**MONTGOMERY COUNTY PLANNING DEPARTMENT**  
THE MARYLAND-NATIONAL CAPITAL PARK AND PLANNING COMMISSION

**MEMORANDUM**

**REVIEW TYPE:** Preliminary Plan of Subdivision

**PROJECT NAME:** Slater Property  
**CASE #:** 120050230  
**REVIEW BASIS:** Chapter 50, Montgomery County Subdivision Regulations

Attachment B – Proposed Preliminary Plan

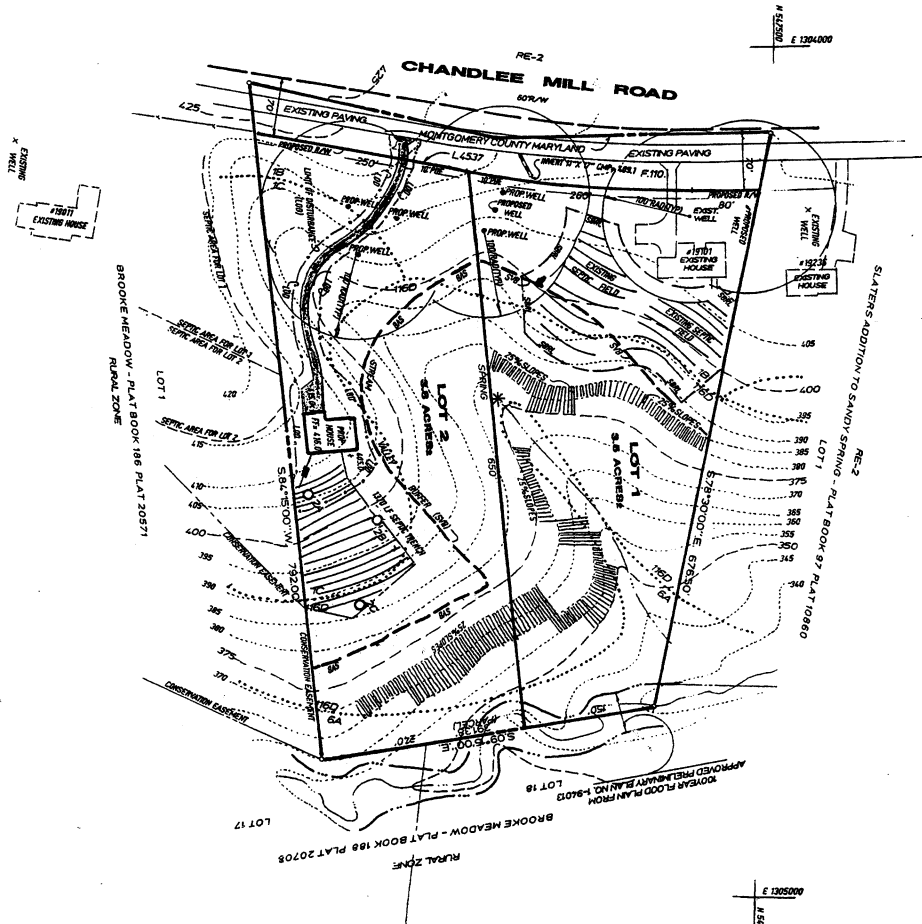
- 3) The applicant must revise the preliminary forest conservation plan to adjust the proposed conservation easement in the area north of the proposed house on Lot 2 so that it follows the 400-foot contour interval. In addition, adjust the proposed conservation easement in the area west of the proposed house on Lot 2 so that it follows the 395-foot contour interval.

- 4) The applicant must submit a revised preliminary plan and revised preliminary forest conservation plan in response to condition 3 prior to certification of the preliminary plan.

1. Show/label all existing planimetric and topographic details specifically driveways adjacent and opposite the site on the preliminary plan.
2. Necessary dedication for Chandlee Mill Road in accordance with the Master Plan.
